**GEOTECHNICAL ENGINEERING
REPORT ADDENDUM**
Buttenwieser/Wiley Residence
6838 96th Avenue SE
Mercer Island, Washington

Project No. 200631 • April 26, 2022

Re: Geotechnical Comment Responses

File Nos. CAO21-007/SHL21-042/SEP21-027 – Buttenwieser/Wiley Residence
6838 96th Ave SE, Mercer Island, WA 98040; King County APN 302405-9010
Aspect Project No. 200631

Site and Exploration Map

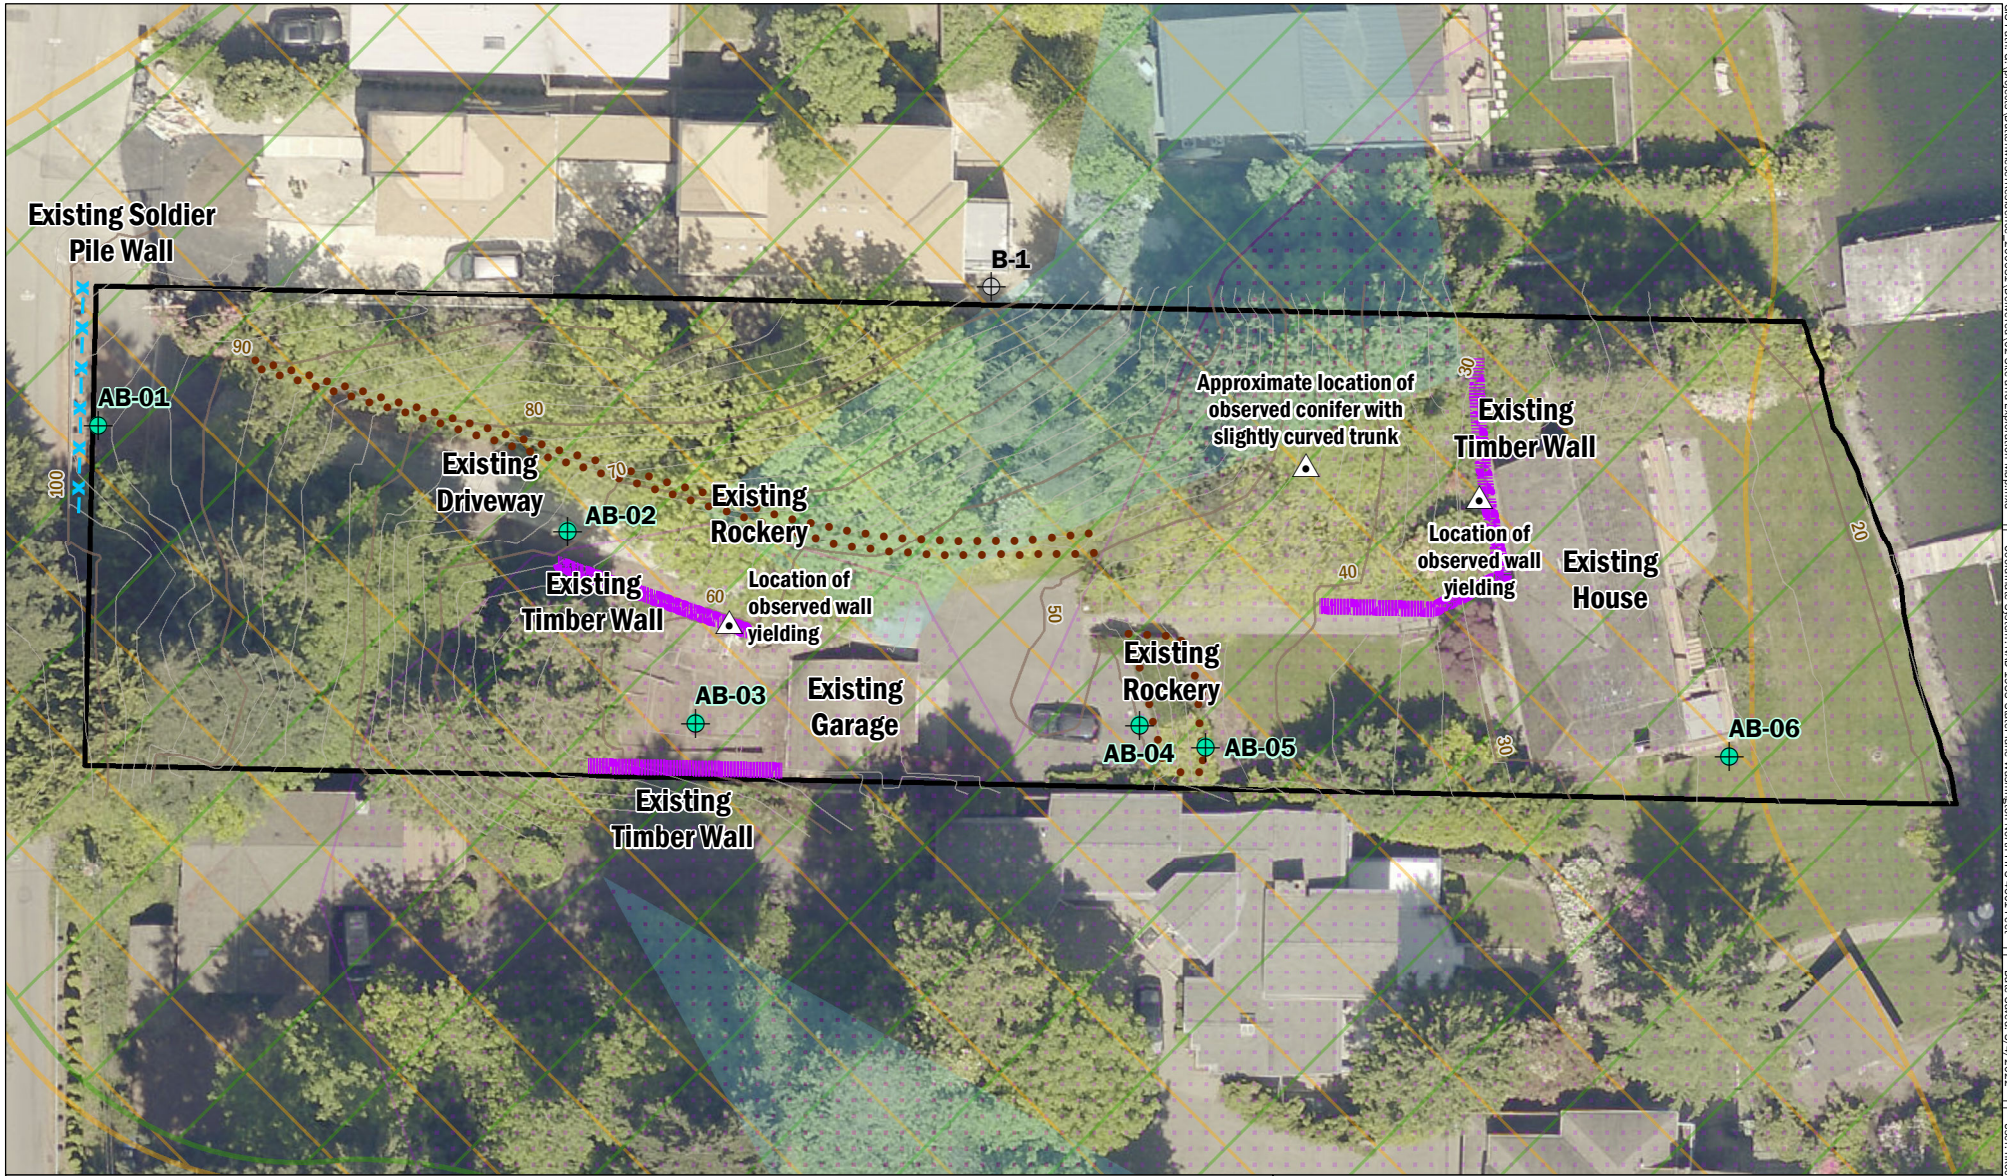
1. *Identify the locations, extents, and magnitudes of yielding conditions of existing retaining walls on a site plan. Include the location of the tree exhibiting response to slope creep discussed in geotechnical report section 2.1.3 on the site plan.*

2. *Specifically for the yielding retaining wall located northwest of the existing residential structure, indicate on a site plan, the location and extent of tension cracking in the soil or ground subsidence that is associated with this yielding condition. Indicate the cause of the yielding and whether the cause extends upslope.*

Our original geotechnical engineering report describes locations where existing retaining walls have yielded and where a tree trunk exhibits curvature. Refer to the Site Plan (Figure 1), which identifies these walls and trees and the extents of observed yielding.

We did not observe tension cracks or noticeable, well-delineated ground subsidence associated with the yielding condition of the wall, nor did the topographic survey performed for the Project capture any localized subsidence at this location. In our opinion, the cause of the yielding is localized surficial slope movement that reflects the age and decay of the railroad tie timbers and/or that the wall was not designed/engineered for the earth pressures it has been exposed to. In our opinion, the slope movement likely extends upslope a distance on the order of inches to a few feet.

Aspect Response: We have included the requested information in our addendum.

Aspect Response: We have included the requested information in our addendum.

Earth Pressure Diagram

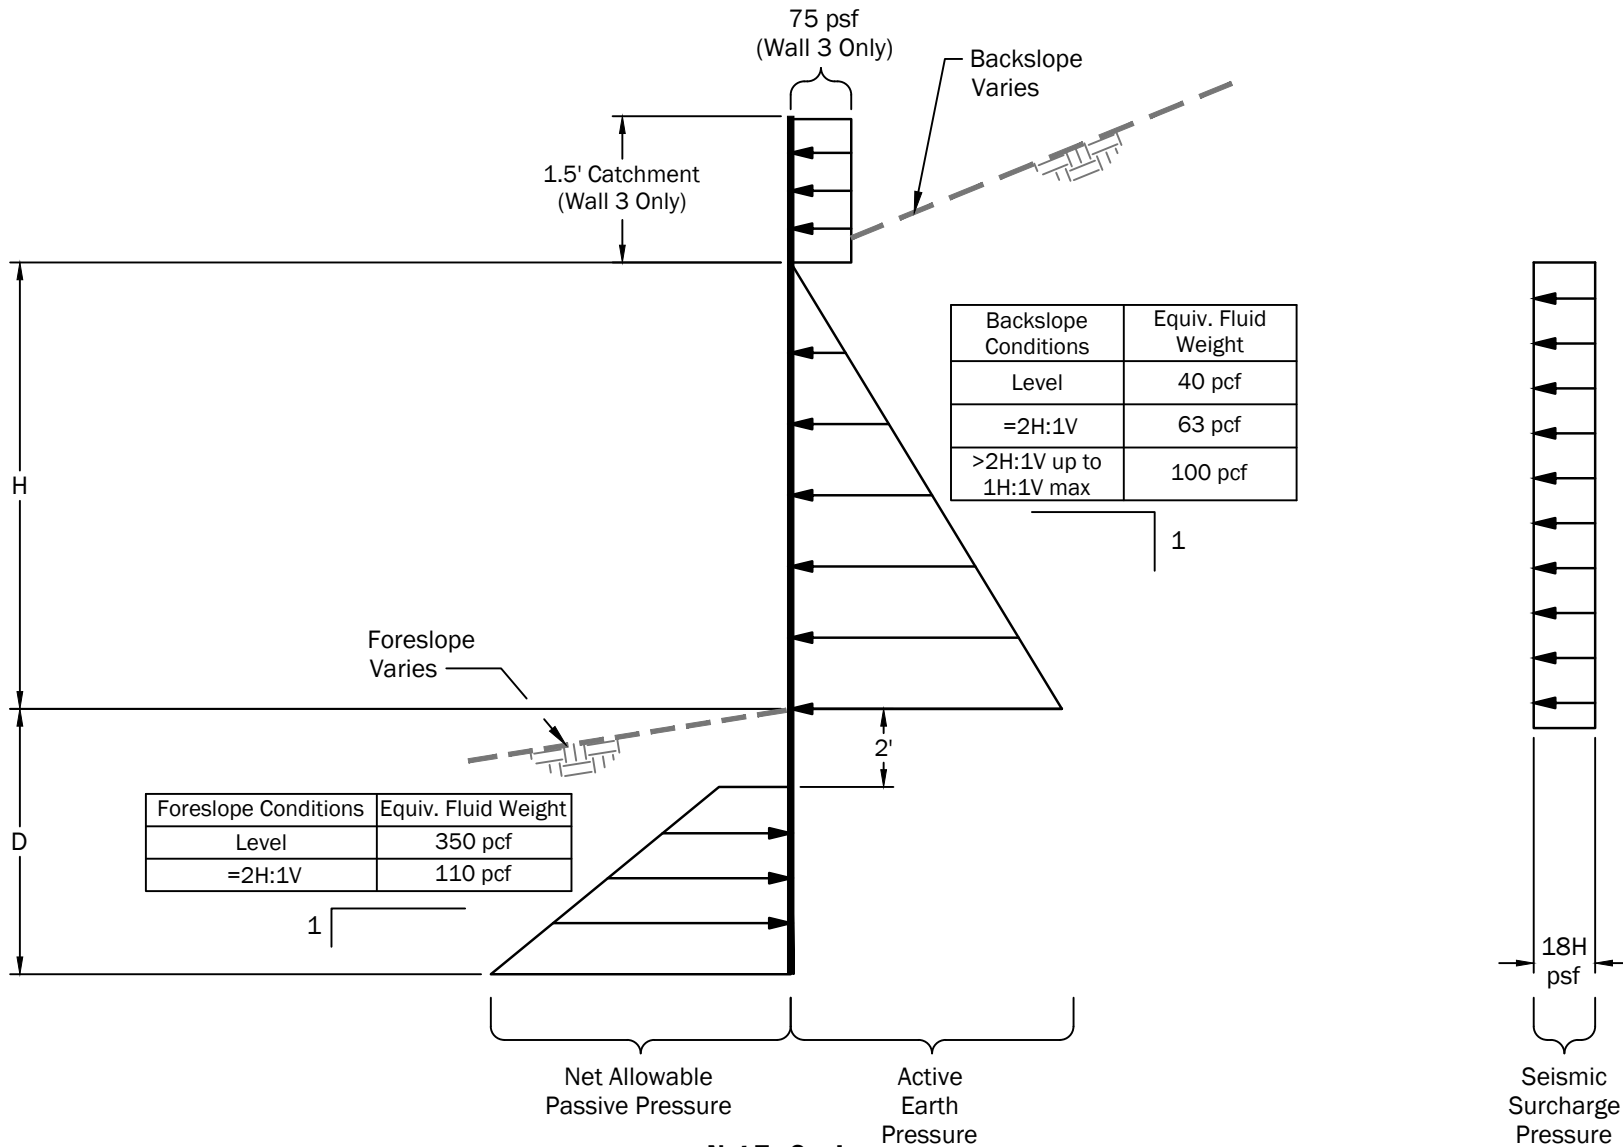
6. *Based on existing topography, backslopes steeper than 2H:1V will be supported by some of the proposed site retaining walls. Geotechnical engineer to provide lateral earth pressures to be used in the design of these walls with steeper than 2H:1V backslopes.*

We included an earth pressure diagram for clarity as Figure 2 with this addendum.

Aspect Response: We have included the requested information in our addendum.

Global Stability Analysis Plan

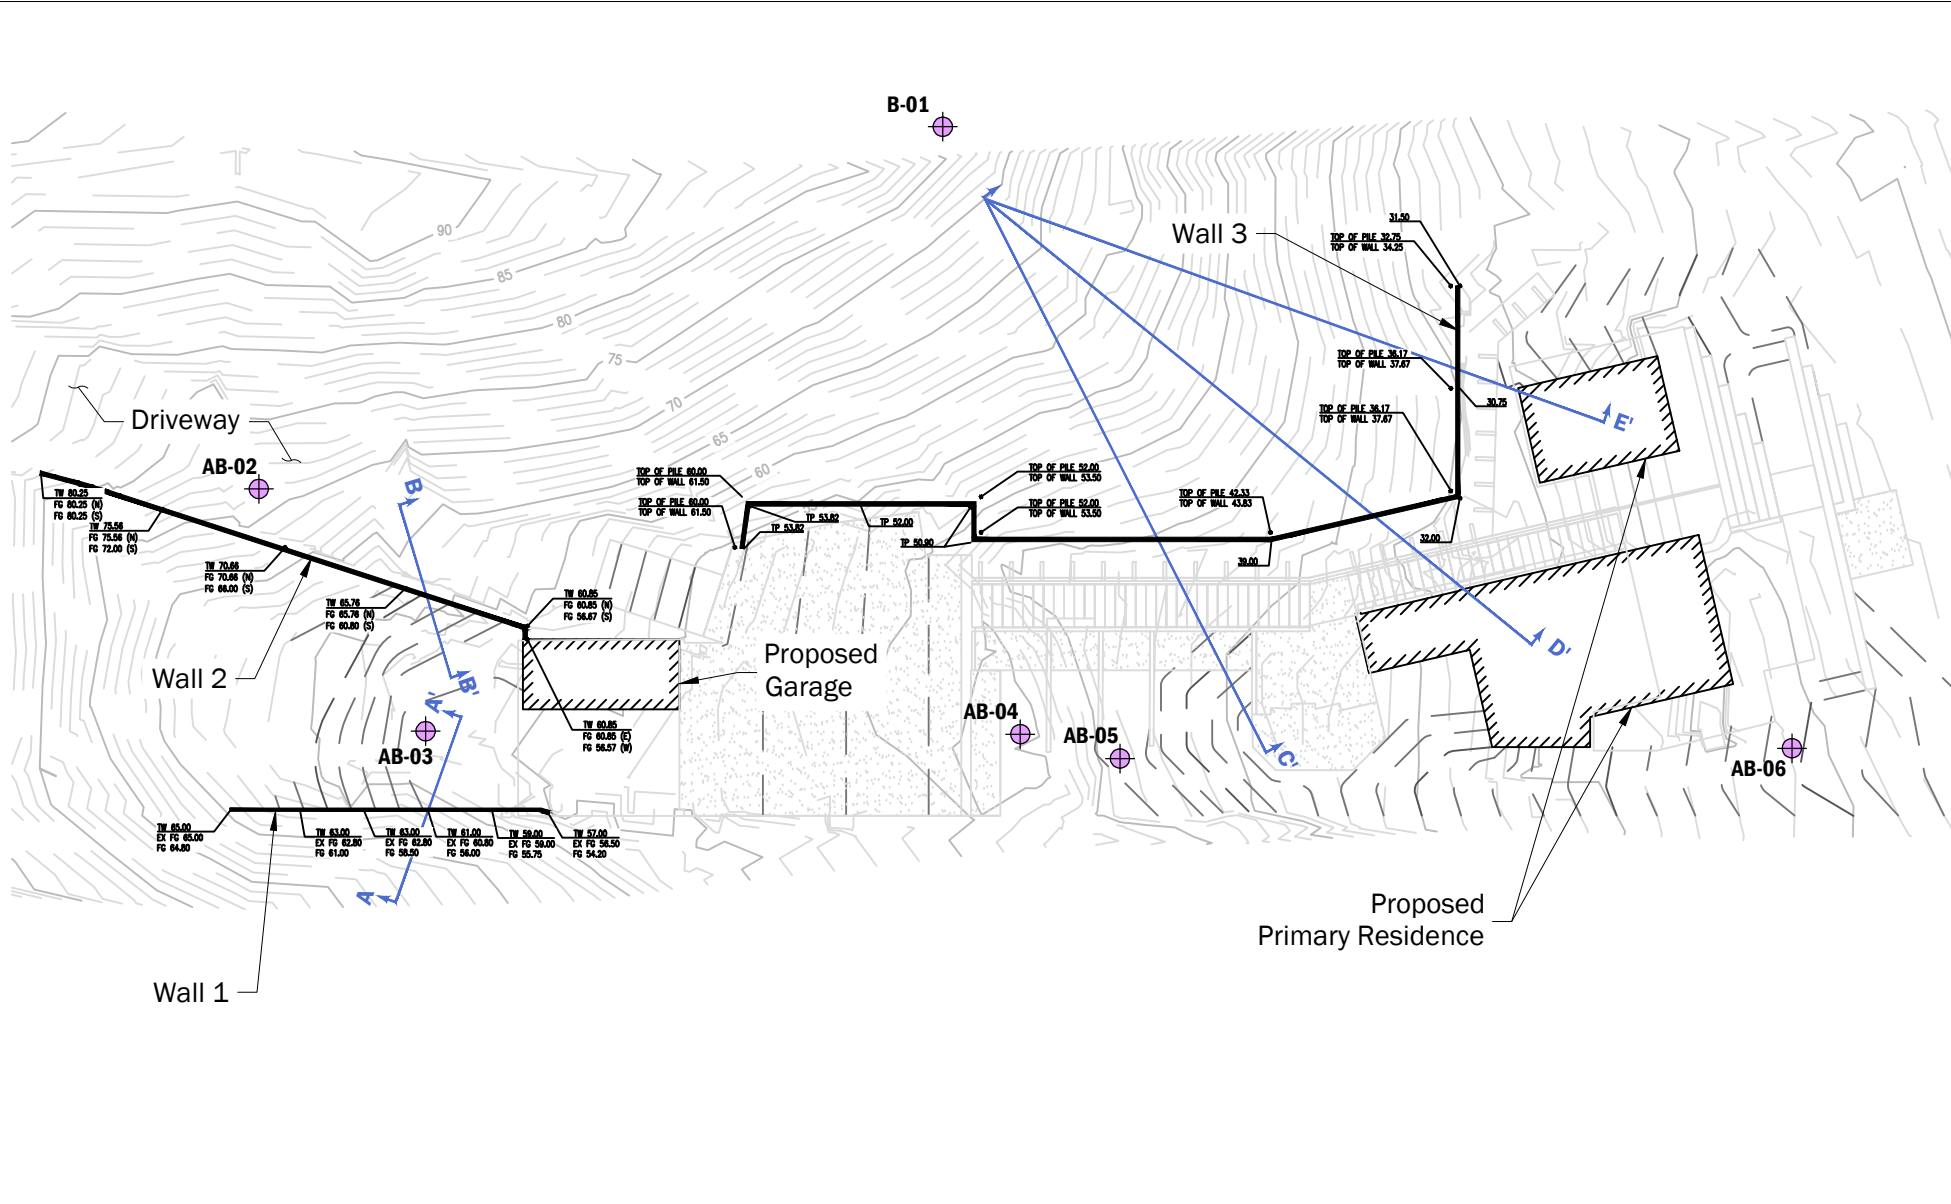
4. *The stability analyses provided in the geotechnical report includes stratigraphy that does not seem to be reflected in the boring logs. Indicate what boring log or detailed geologic reconnaissance information is associated with each wall cross section presented in Appendix C of the geotechnical report.*

These walls, as well as preliminary grading information provided by the design team, are shown on Figure C-1 in Appendix C. The following sections contain design and construction recommendations for the proposed retaining walls.

Aspect Response: The stratigraphy in the slope stability model represents our generalized interpretation of the subsurface conditions, based on the totality of our subsurface exploration program and our local geologic experience. The relative location of each cross section and nearby borings can be seen in Appendix C-1 of the addendum. It should be noted that the explorations are at locations and elevations that do not directly project to the modeled stratigraphy in all cases. Our modeled assumptions are reasonable and appropriate based on the variable topography and our interpretation of the subsurface and the proposed Site grading. For your information, we also included logs from a previous nearby

Section E-E' Catchment

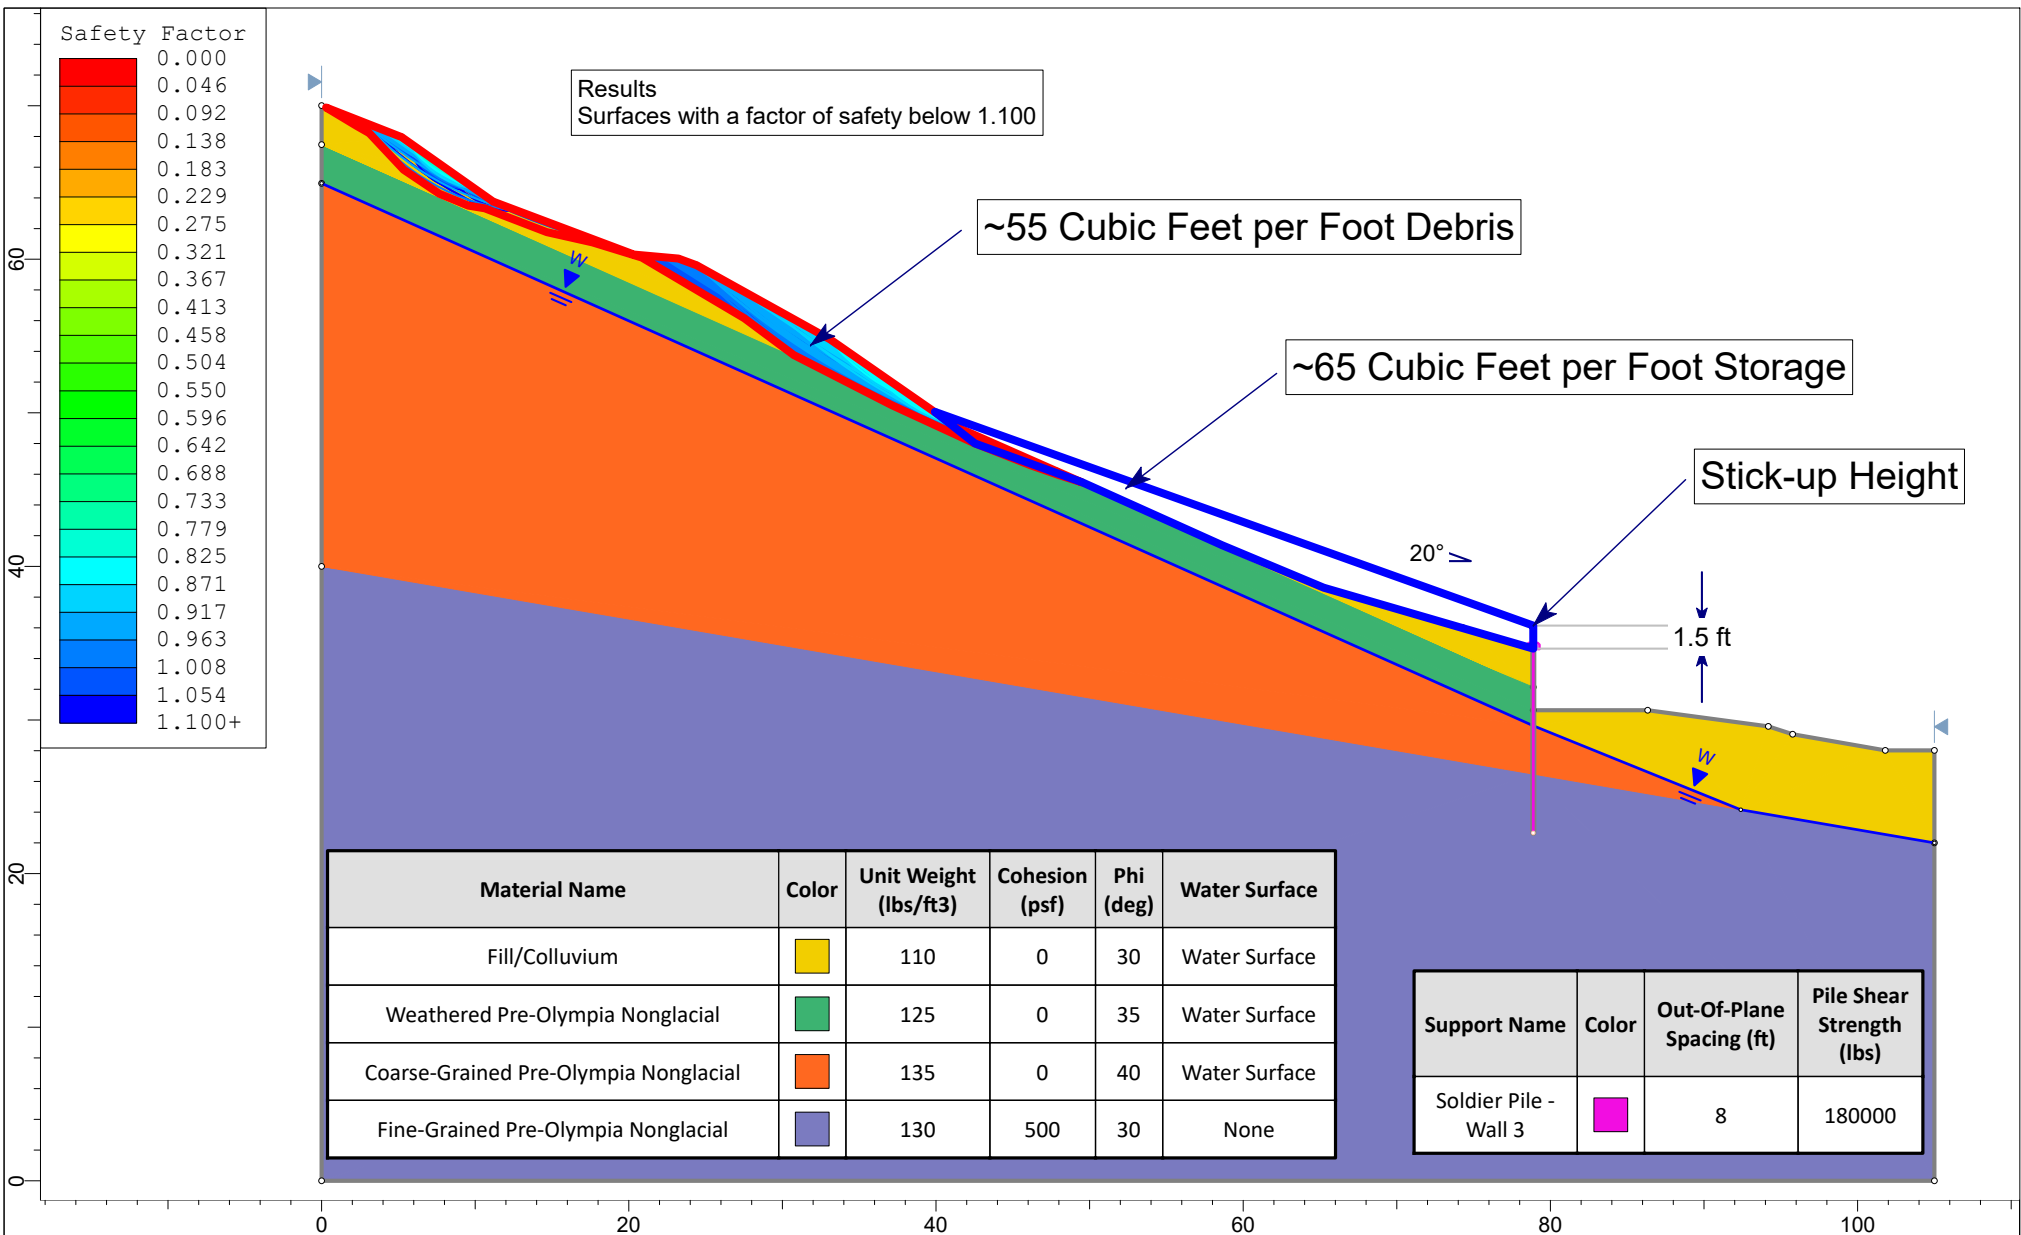
7. *The geotechnical engineer identified a moderate risk for shallow landslides at this site. Given the proximity of the proposed structures to the steep slopes, the geotechnical engineer shall provide a discussion as to whether the proposed site retaining walls should include a catchment feature and if so, provide design recommendations so that the structural engineer can incorporate a catchment feature to the top of the wall.*

If no catchment feature is recommended, indicate whether a surficial landslide from the steep slope area could physically impact the proposed residential structures. Indicate how this would not pose a threat to public health and safety.

We performed stability analyses of the shallow landslide hazard to identify whether a catchment feature should be provided on the proposed soldier pile wall located at the base of the ECA steep slope north of the main residence (Wall 3). We analyzed sections C-C,' D-D,' and E-E' (refer to Appendix B) and found that section E-E' governed our catchment recommendations.

Based on our interpretation of the failure surfaces and ranges in calculated factors of safety, it is our opinion that a unit volume of slide debris expected to mobilize during a characteristic shallow slide is approximately 55 cubic feet per foot of slope width. Assuming the slide debris will come to rest at the base of the slope with a residual backslope of approximately 20 degrees, we recommend a minimum extra stick-up height for debris catchment of 1.5 feet above existing grade at the top back of the wall. These calculations are represented graphically in Appendix D. We recommend the wall be designed to resist lateral forces exerted by the shallow landslide debris. In our opinion, a uniform lateral load of 75 pounds per square foot, distributed uniformly over the stick-up height, can be used for design. This is presented graphically in the earth pressure diagram on Figure 2.

Aspect Response: We have included the requested information in our addendum.
